Access Compliance Report

Public Rights-of-Way

(Curb Ramps)

Intersection ID: 30466	Main Street: PLANTERS_ROW_DR	Cross Street: POPLAR_FOREST_DR	Location: NE
ADA ID: 1C240034C34C	Ramp Type: PerpDiag	Initial Pass/Fail: Fail	Overall Compliance: No
Severity Score: 13.75			
Codes/Mitigation Info/Possible Solution		Field Measurements/Component Compliance

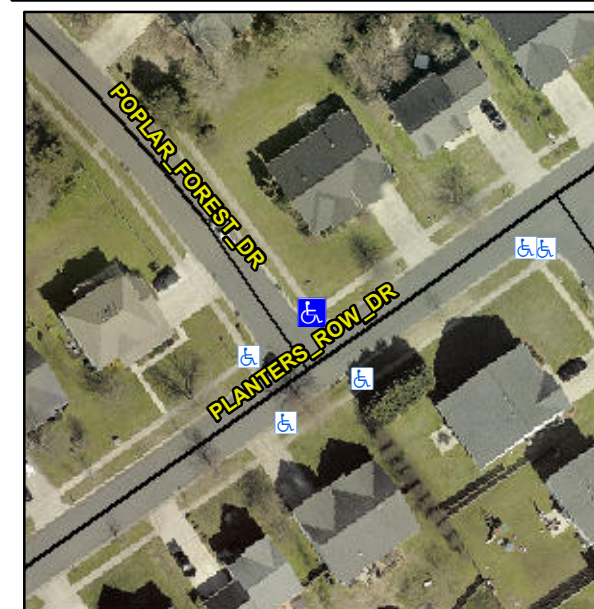
R304.2.2, R304.5.3

Compliance	Description	Data	Compliance	Description	Data
N/A	Ramp Length (in)	57.0	No	Ramp Slope (%)	10.8
Yes	Ramp Width (in)	50.0	No	Ramp XSlope (%)	3.1
N/A	Flare Type LT	N/A	N/A	Flare Type RT	N/A
N/A	Flare Slope LT (%)	N/A	N/A	Flare Slope RT (%)	N/A
N/A	Flare Traversable LT?	N/A	N/A	Flare Traversable RT?	N/A
N/A	Landing Length (in)	N/A	N/A	DWS Provided?	N/A
N/A	Landing Width (in)	N/A	N/A	DWS Contrast?	N/A
N/A	Landing Slope (%)	N/A	N/A	DWS Length (in)	N/A
N/A	Landing X Slope (%)	N/A	N/A	DWS Full Width?	N/A
N/A	Landing Curb? (Y/N)	N/A	N/A	DWS Offset (in)	N/A
N/A	Shared Landing?	N/A			
N/A	Gutter Ponding?	N/A	N/A	Gutter Slope (%)	N/A
N/A	Gutter Lip Ht (in)	N/A	N/A	Gutter X Slope (%)	N/A
N/A	Painted X Walk1?	No	N/A	Painted X Walk2?	No
	X Walk 1 Direction	To SW		X Walk 2 Direction	To SE
N/A	X Walk 1 Width (in)	N/A	N/A	X Walk 2 Width (in)	N/A
	X Walk 1 Slope (%)	0.7		X Walk 2 Slope (%)	4.0
	X Walk 1 X Slope (%)	3.6		X Walk 2 X Slope (%)	0.2

Remove & Replace Curb Ramp With Two New Directional Ramps or Equivalent.
